# **Groundwater Transfer Review Summary Form**

## Transfer/PA # T- <u>13777</u>

GW Reviewer \_James Hootsmans/Josh Hackett \_ Date Review Completed: April 8, 2024

# Figure 1. Well Location Map

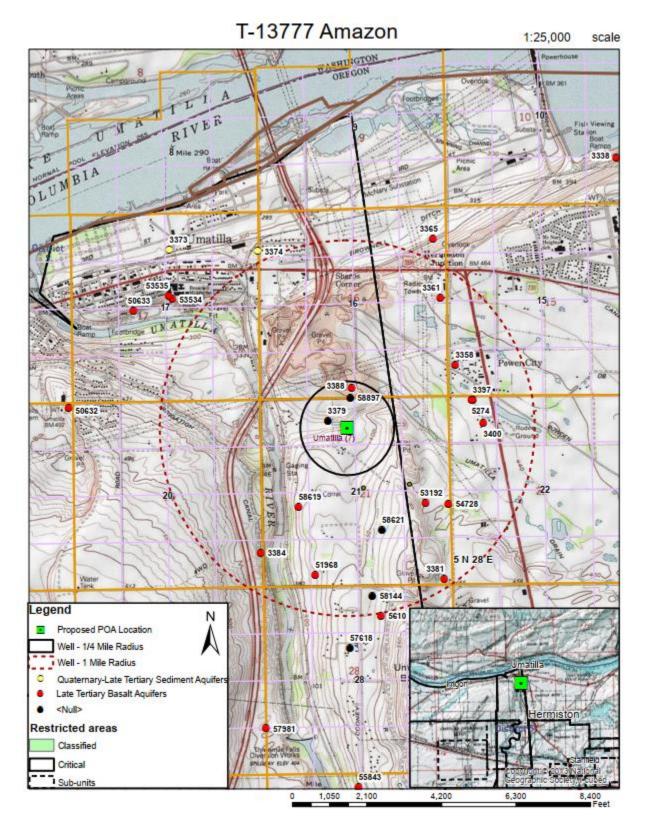
The applicant has proposed a change in the authorized POA, from UMAT 3388 to Proposed Well 1. Proposed Well 1 will be located within the boundary of the Section 21 subarea of the Butter Creek CGWA and will be approximately 1200' south of the authorized POA. According to the application, Proposed Well 1 will be drilled to a total depth of 250' bgs and will be cased and sealed to 75' bgs. The proposed POA will be 150' deeper than the authorized POA and will likely produce from a different aquifer.

The technical memorandum provided with the updated application documents (received May 19, 2023) indicates that Proposed Well 1 will be constructed in the Pomona member. However, geologic cross sections provided in the memo show the authorized POA (UMAT 3388) develops the WBZ in the flowtop of the Pomona member, whereas the Proposed POA (Proposed Well 1) will develop the WBZ at or near the interflow zone between the base of the Pomona, the Selah interbed, and the top of the Umatilla member. These WBZs are separated by over 100 feet of dense, low-permeability flow interior that likely limits hydraulic connection between them.

## Figure 2. Well location map with geology and Critical Groundwater Area boundaries.

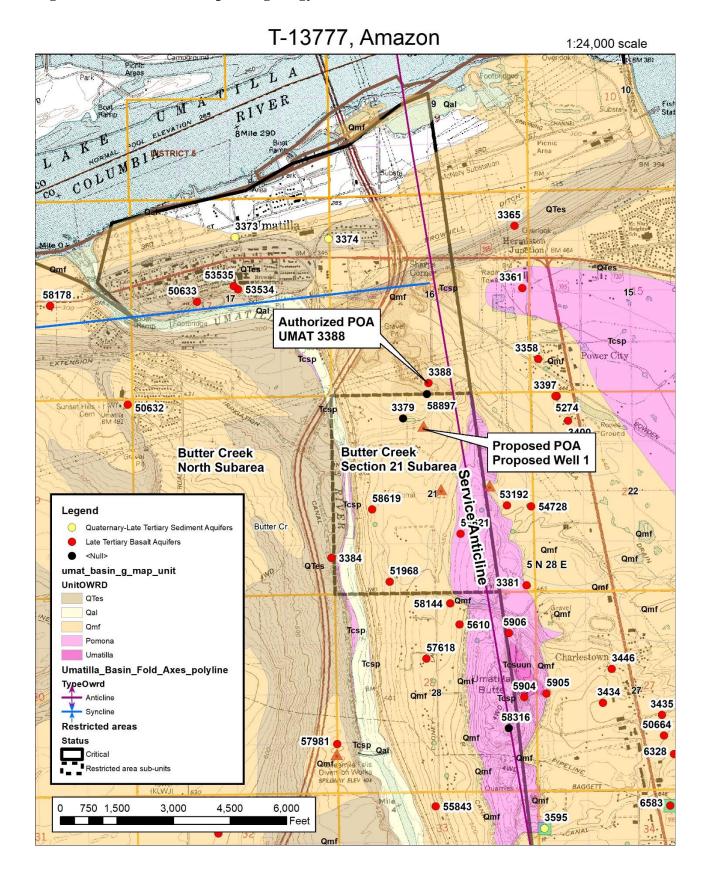
<u>UMAT 3388 is located within the physical boundary of the Butter Creek Critical</u> <u>Groundwater Area (CGWA) (Figure 2) but is not subject to restrictions of the CGWA.</u> <u>However, UMAT 3388 likely produces from the same aquifer as UMAT 51968, a well in</u> <u>the Section 21 Subarea of the Butter Creek CGWA. UMAT 51968 was drilled to a total</u> <u>depth of 70 feet and likely also produces from a WBZ near the top of the Pomona member.</u>
